Professional Staff Report
May 19, 2016

**770 Shabbona Drive
Big Foot Country Club**

Proposed Conditional Use Permit: Septic System

Mound Cross Section

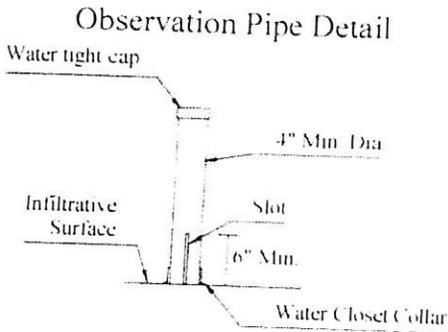
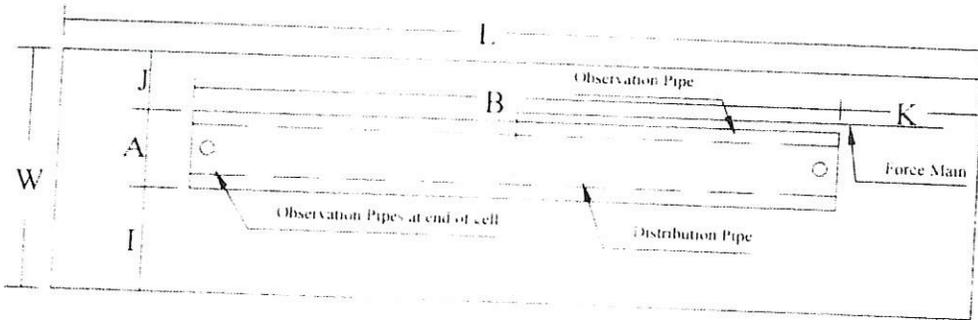
- Page 2 – System Elevation = 99.5 Feet
- Page 2 – Invert of Distribution Pipe = 100.0 Feet
- Preserve dispersal area prior and during construction to avoid disturbance, compaction and use of the site.
